Technical Service Bulletin: TSB150027

New Cylinder Liner Crevice Seal and Associated Cylinder Liner Part Numbers

Figure 1, New Cylinder Liner and Upper Crevice Seal Installed in Cylinder Block

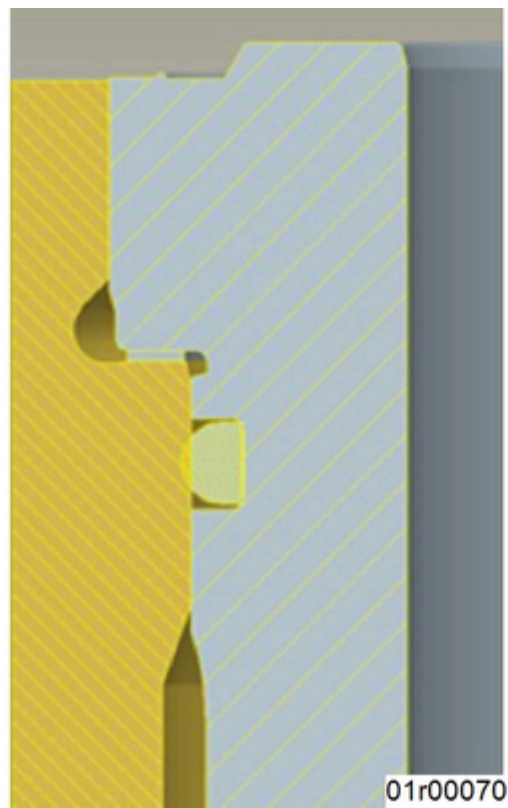
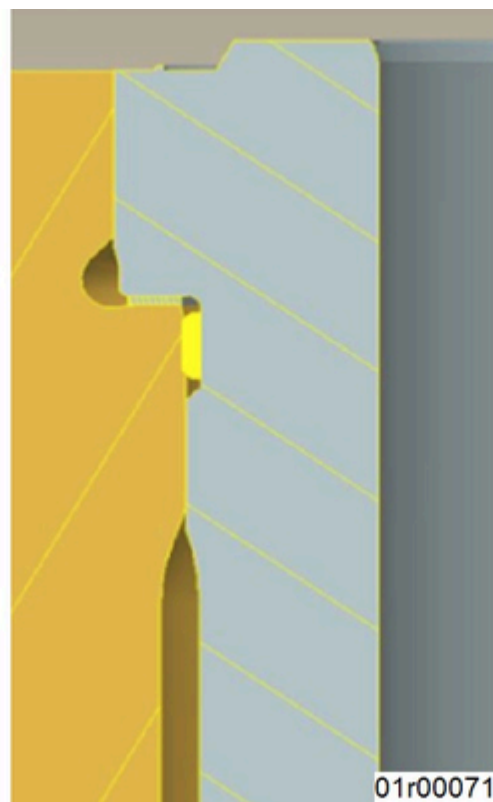
The new cylinder liner crevice seal groove now sits further down in the lower press fit area. The groove acts as a positive locator for the upper crevice seal, which minimizes vertical movement of the seal during installation. The new upper crevice seal is now a D-shape design. The seal material remains unchanged. See Figure 1 below. The previous cylinder liner crevice seal groove sat higher in the lower press fit area and did **not** have a positive locator, which could allow the seal to move vertically during installation. The previous upper crevice seal was a rectangular design. See Figure 2 below.

The new cylinder liner and upper crevice seal is more robust and helps to reduce seal pinching between the cylinder liner flange and brass sealing ring during cylinder liner installation. This can help reduce coolant leaks from the cylinder head gasket area.

New crevice seals are compatible with new cylinder liners only. Existing crevice seals are compatible with existing cylinder liners only.
